Addendum # 004

TENDER NUMBER: 619-CP2003

Renovations and Atrium Project

Our Lady of Fatima Catholic School

REVISION TO DRAWING M201.4

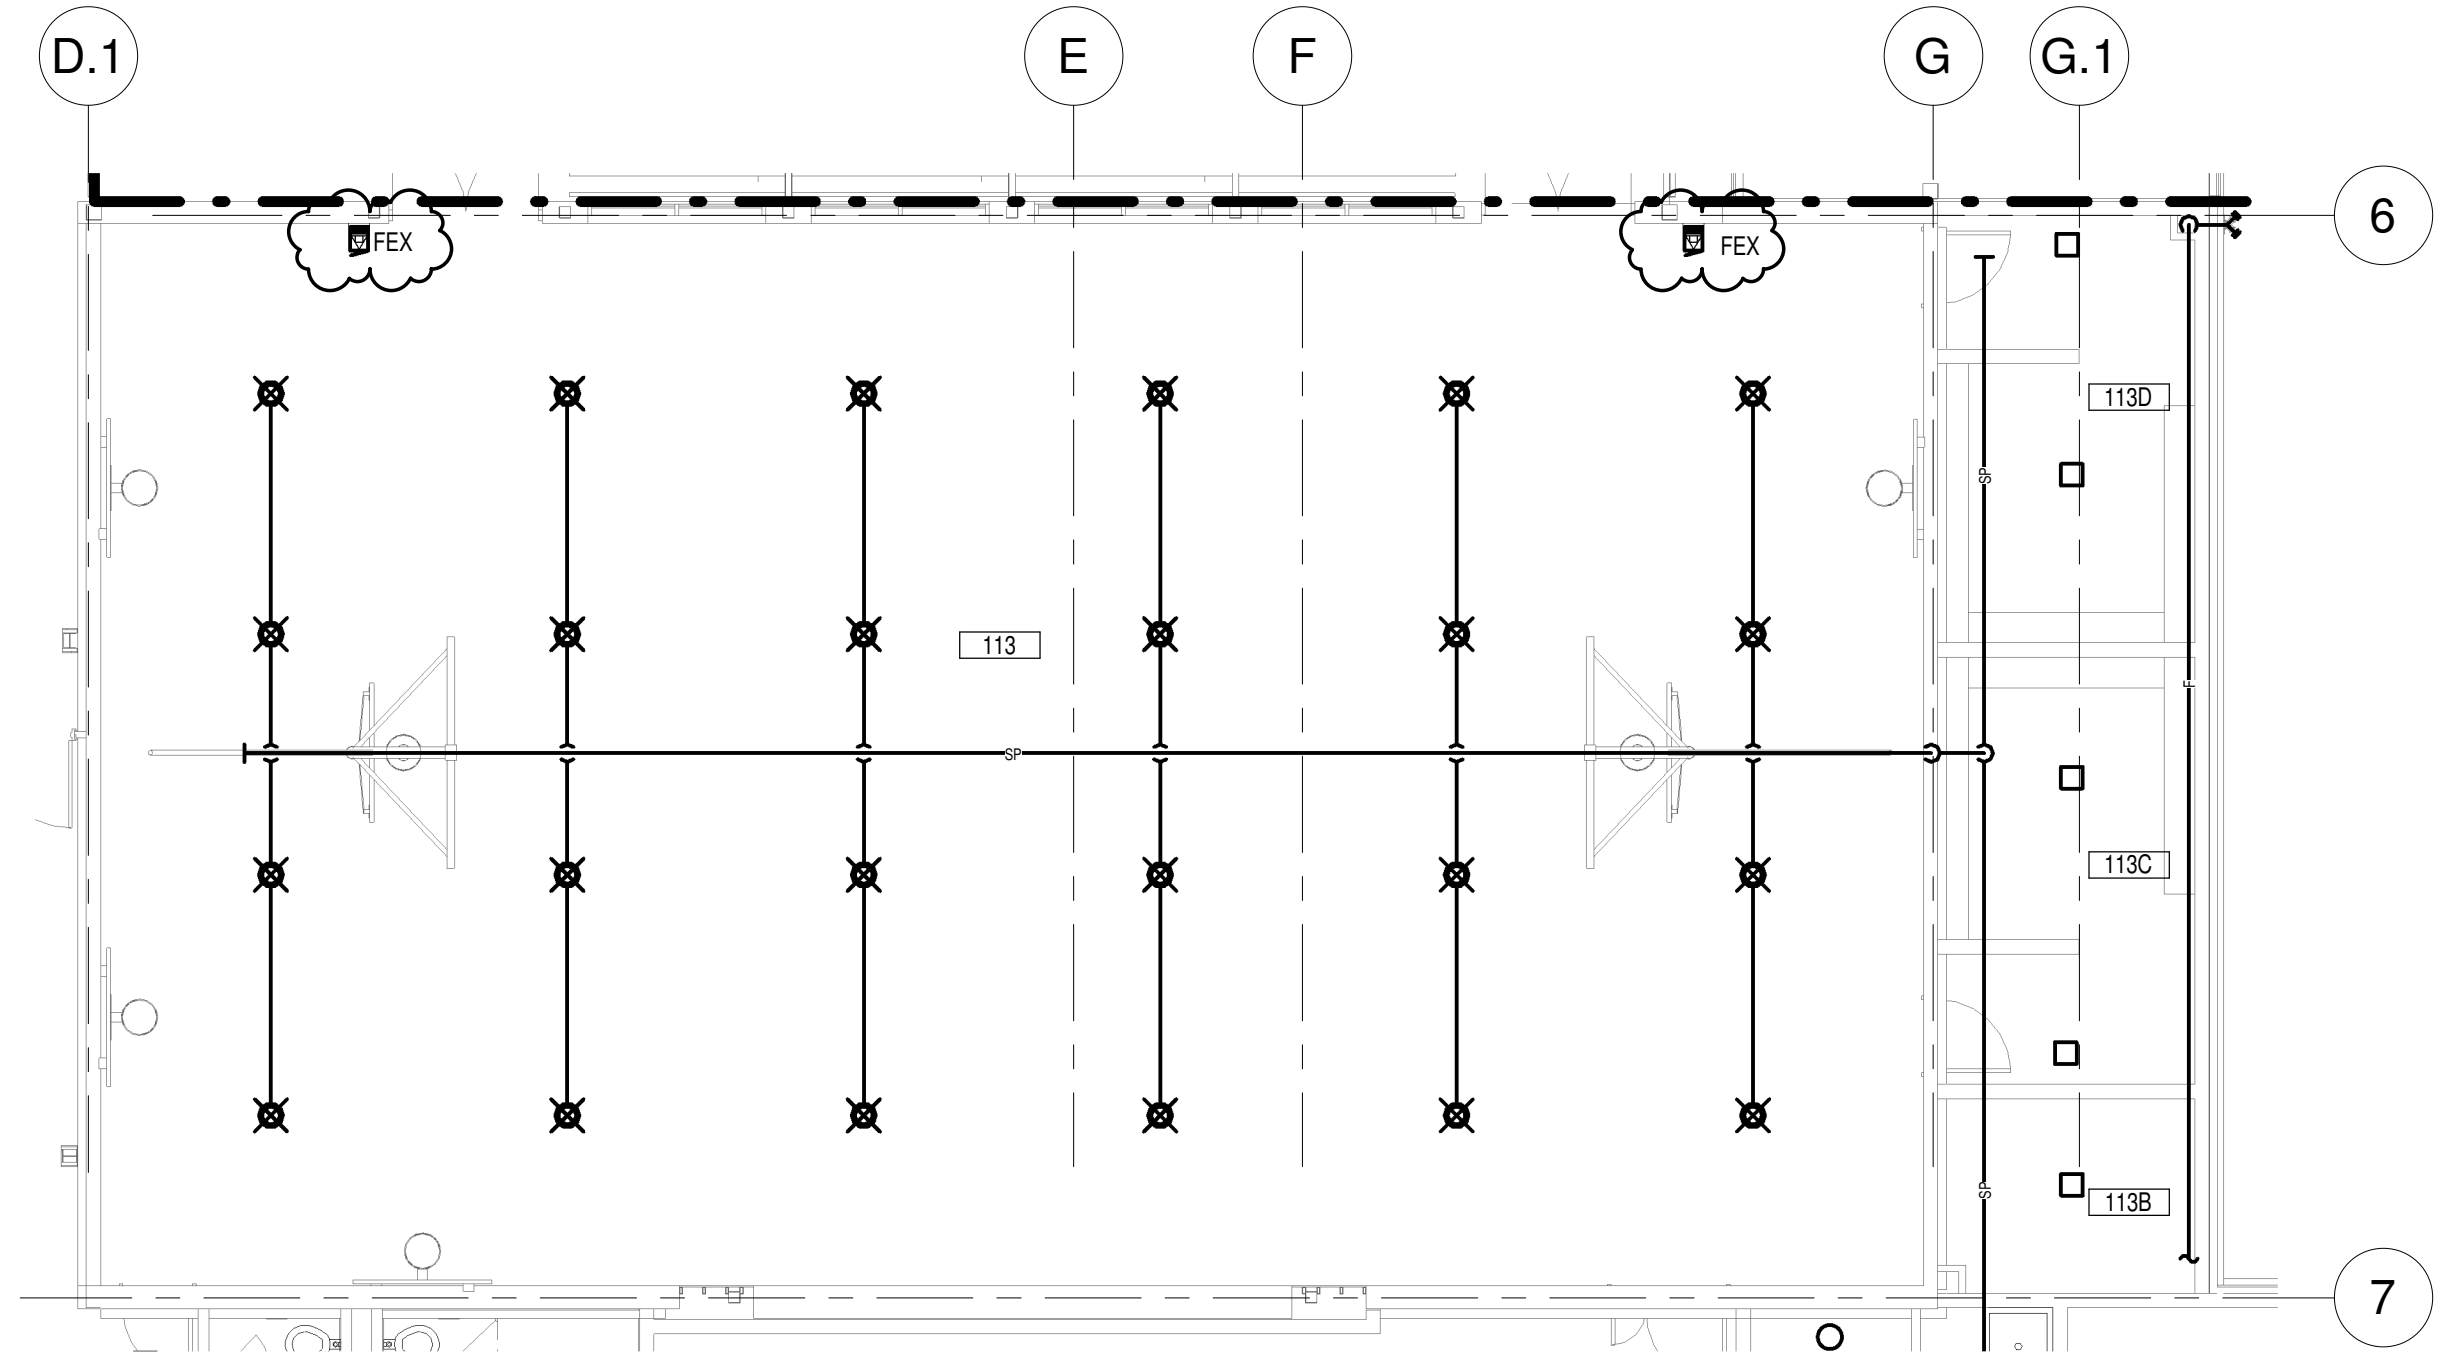
3. Drawing M201.4 - Part Ground Floor Plan - Drainage North

1. Remove section markers.
2. Refer to revision drawing MR-2, attached.

REVISION TO DRAWING M402.4

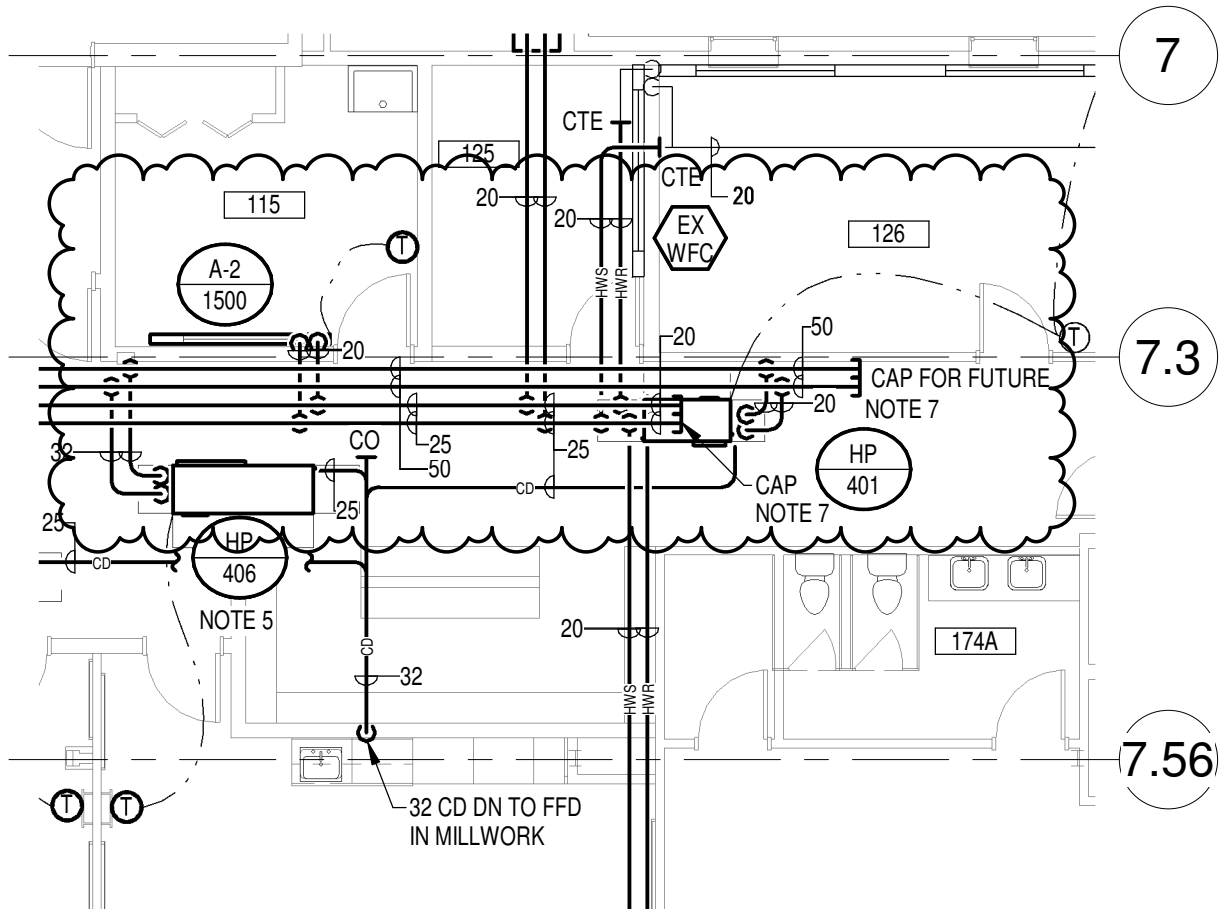
8. **Drawing M402.4 - Part Ground Floor Plan - Heating South**
 1. Refer to revision drawing MR-4, attached.
 2. Refer to revision drawing MR-5, attached.

REVISION TO DRAWING M707.4

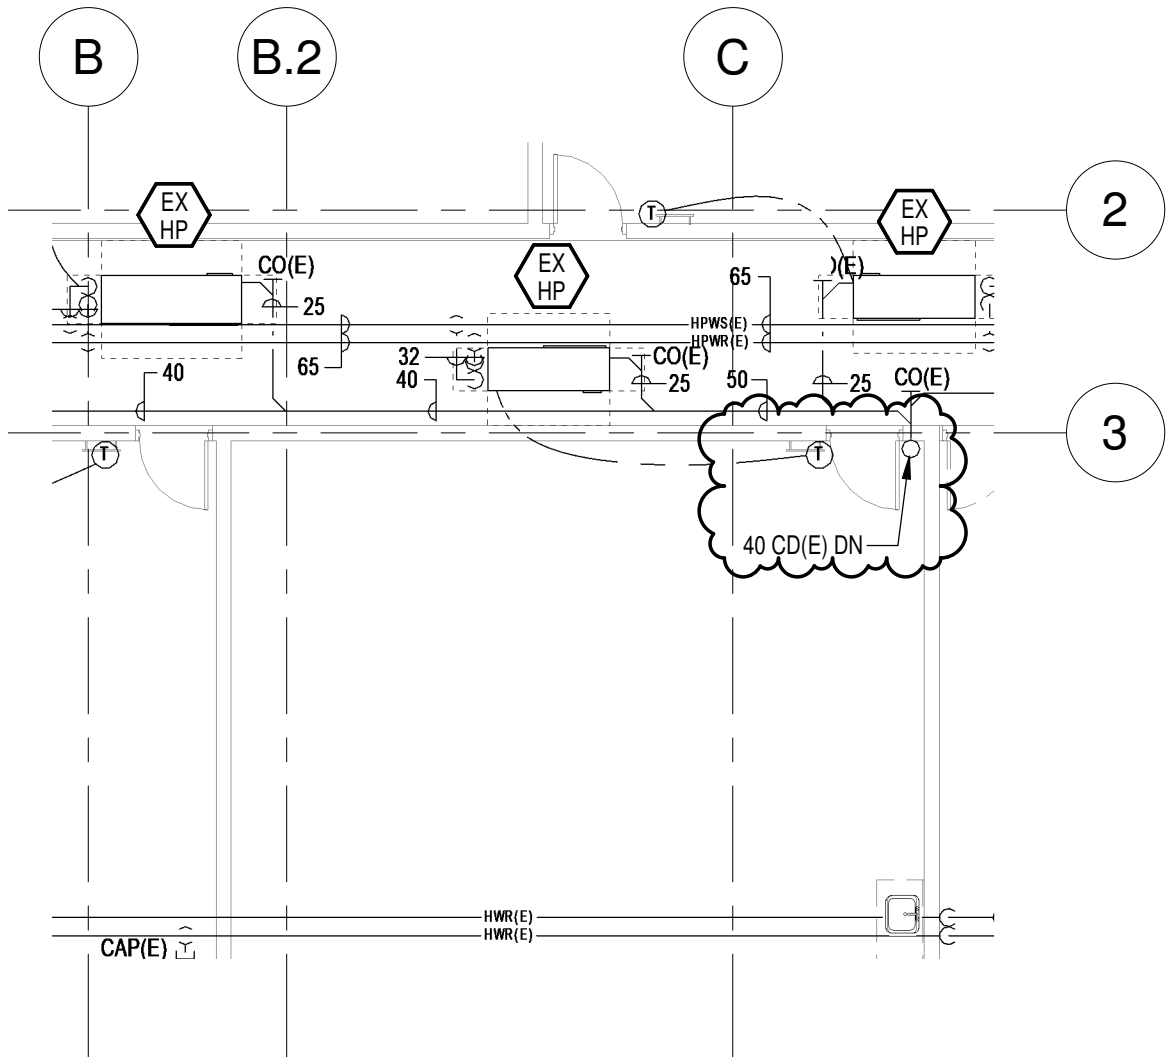
16. **Drawing 706.4 - Part Ground Floor Plan - Drainage Demolition**
 1. Fire extinguishers show are existing to remain.
17. **Drawing 707.4 - Parr Ground Floor Plan - Heating North Demolition**

1. Refer to revision drawing MR-6, attached.
18. **Drawing 709.4 - Part Ground Floor Plan - Air Distribution Demolition**
 1. Refer to re-issued drawing, attached.
